Planning Commission Agenda
May 17, 2023

RE: Hillsdale College Sajak Media Center Site Plan Review

Plans for the proposed Sajak Media Center Building for Hillsdale College located at 111 E Fayette St. were reviewed by the City Dept. Heads on May 3, 2023. Their comments are as follows:

RE: Hillsdale College Classic Education Building Site Plan Review

**UNDERGROUND DETENTION CHAMBER
SECTION DETAIL**

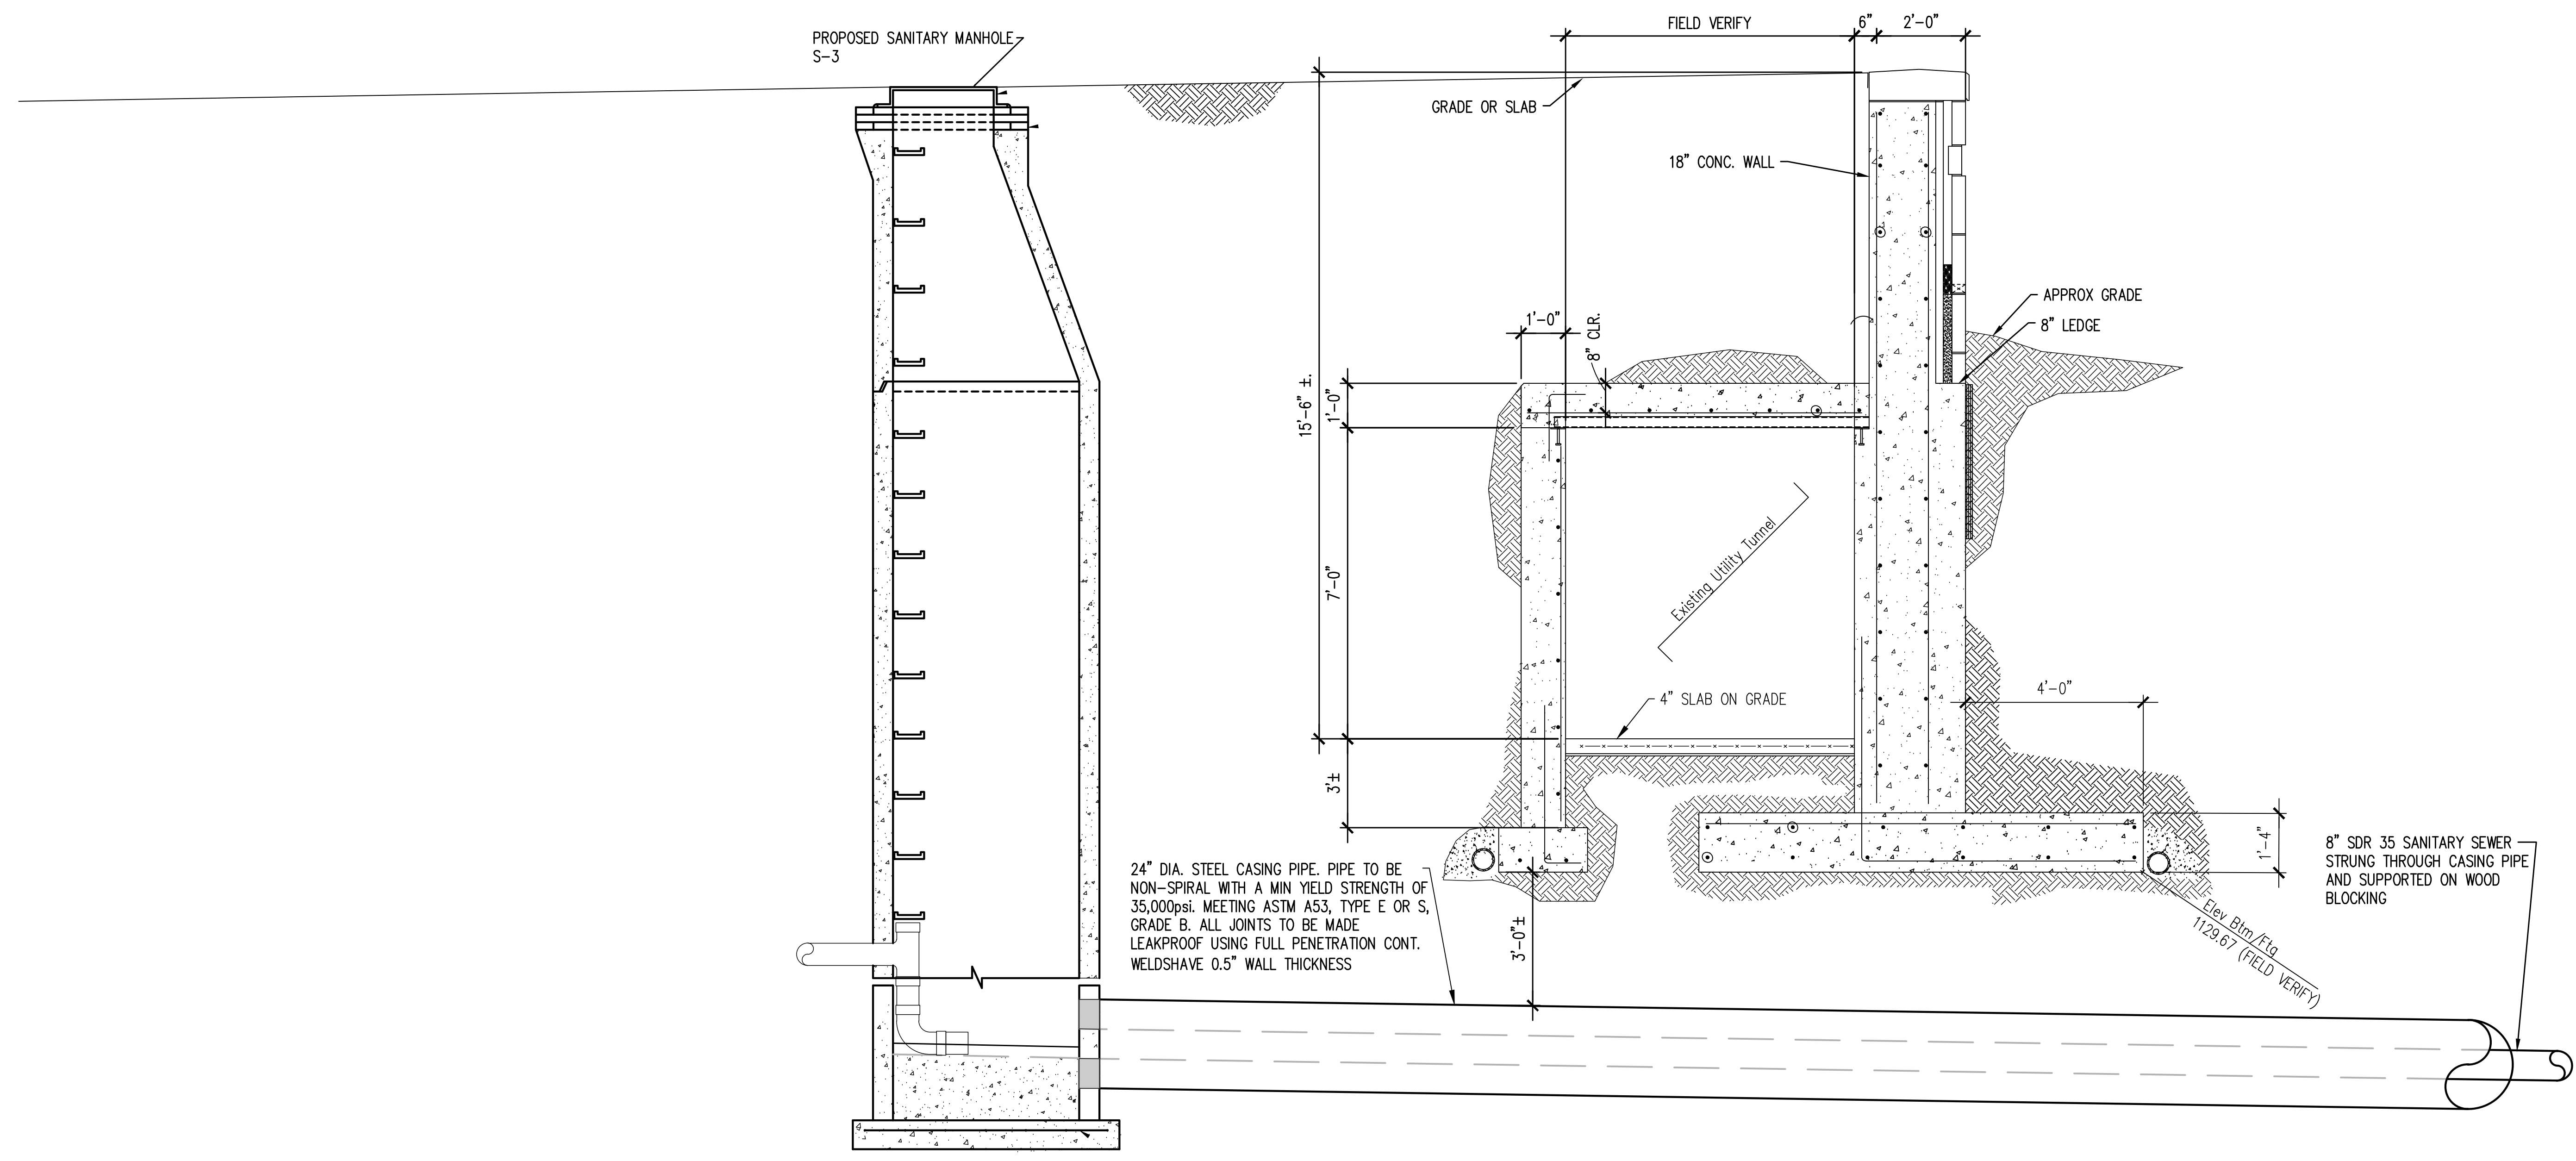
- Verify CB 18, 19 & 22 are 15" RCP.
- Key notes need to be reviewed and corrected.
- Storm Schedule
 - Call out sheet number referenced.
- Suggested reroute of storm not to avoid future library building expansion. (CB 24 thru 26)
- Revise detail of underground detention chamber.
